THE EFFICIENT 2-STORY  
436 NATCHEZ TRACE  
FUQUAY-VARINA, NC 27526

**436 Natchez Trace**  
**Fuquay Varina, NC**  
**Family Building Co.**

Job Number:  
1009-22

**S1**

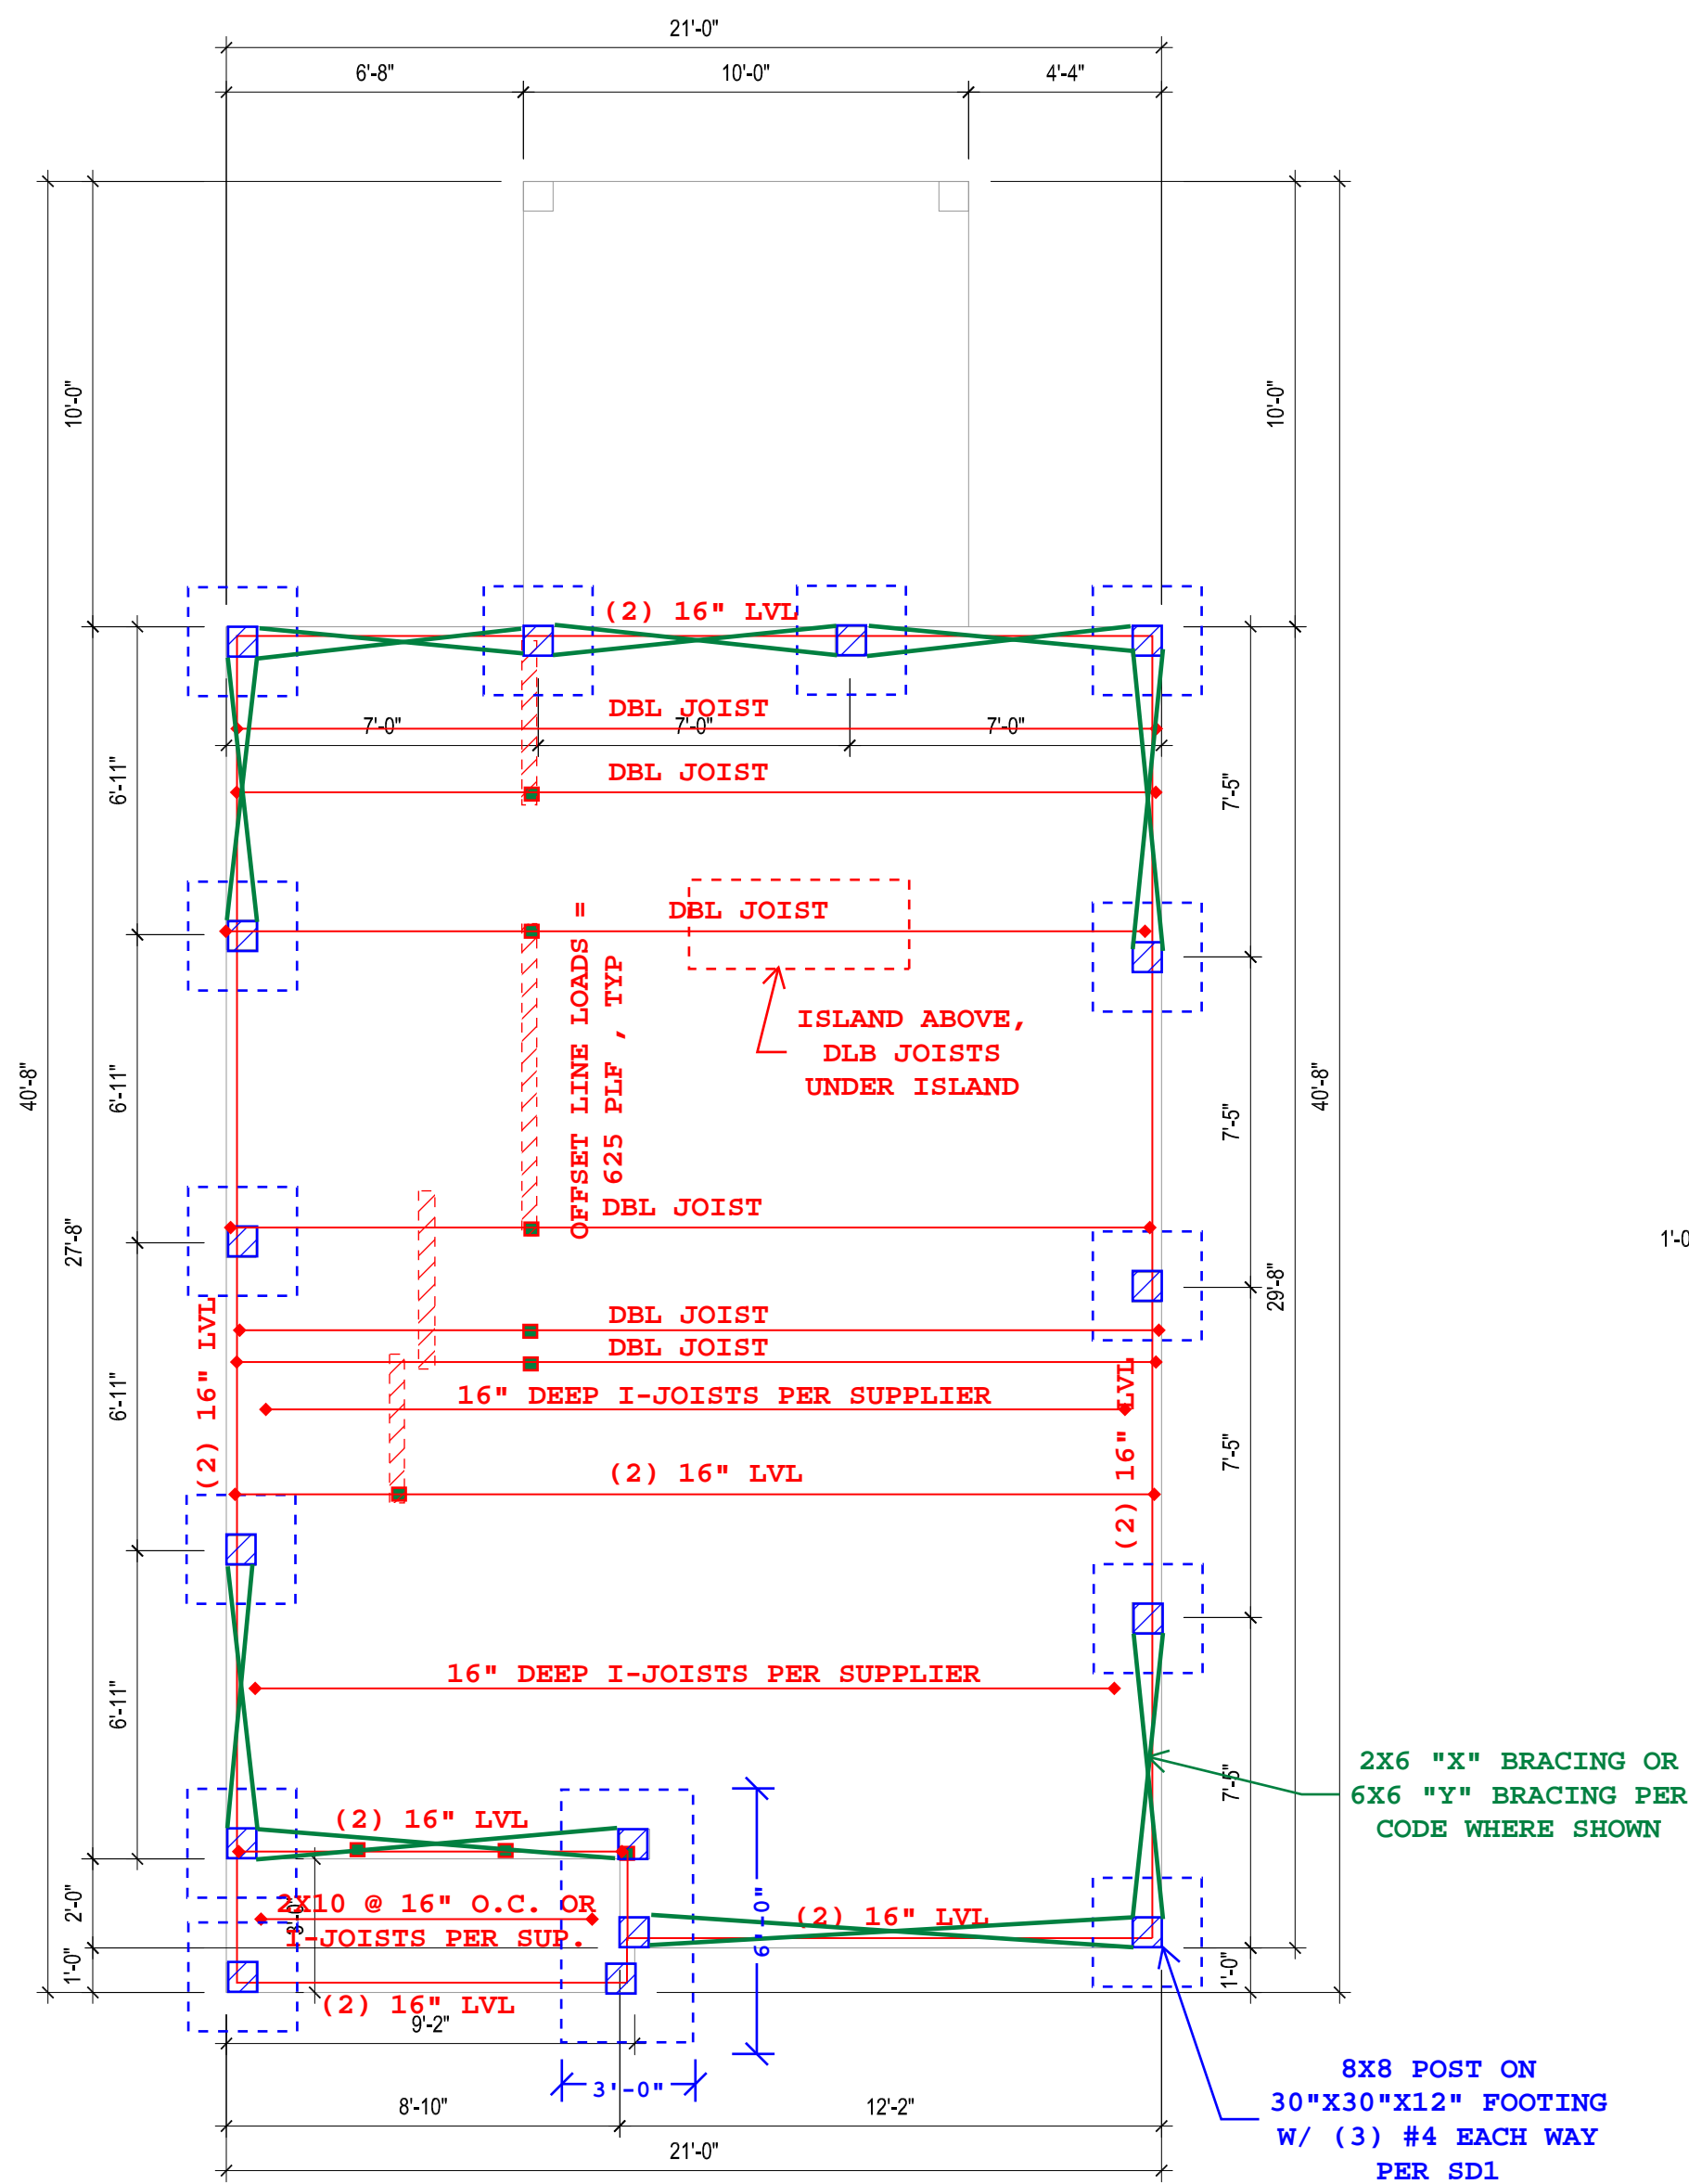
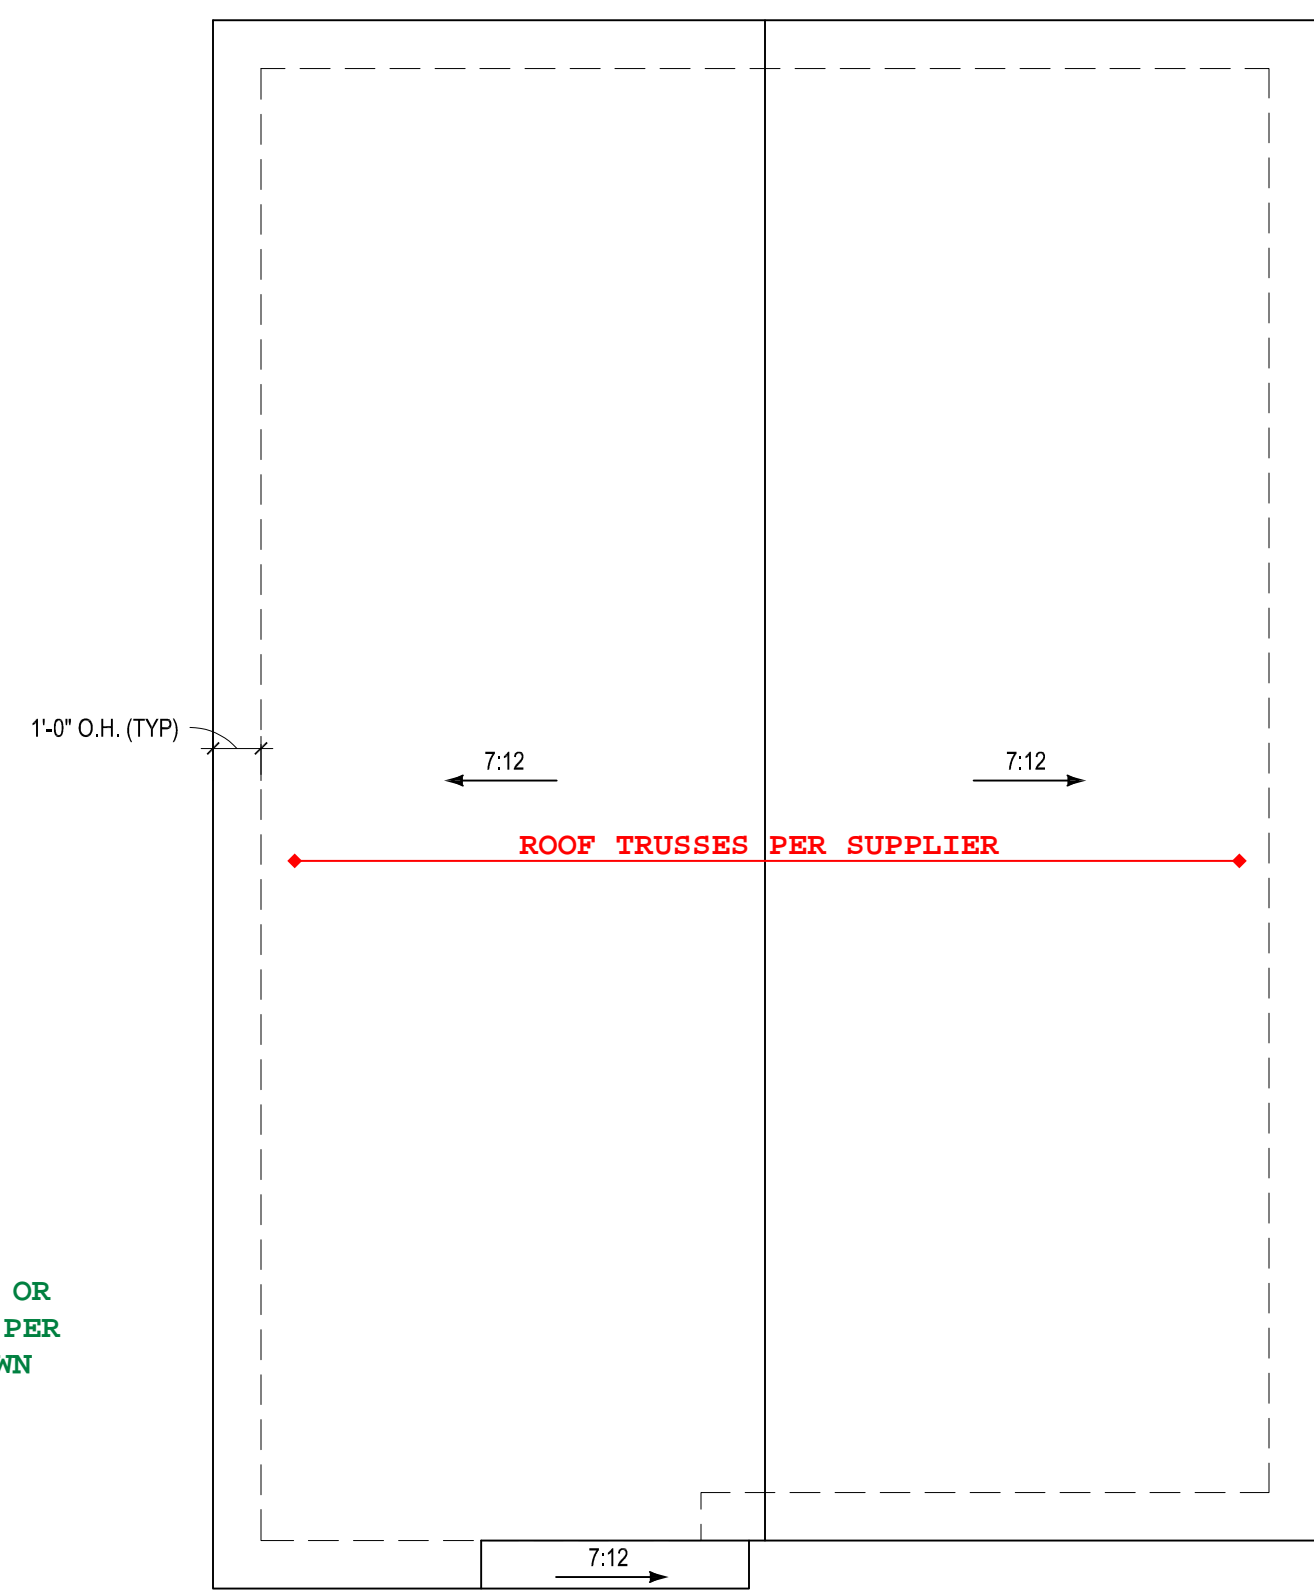
\*ALL LUMBER TO BE #2 SYP, UNO

\*ALL LUMBER TO BE #2 SYP, UNO  
BUILDER MAY USE ROOF TRUSSES. TRUSS DESIGN, LAYOUT, AND  
ENGINEERING TO BE PROVIDED BY TRUSS MANUFACTURER
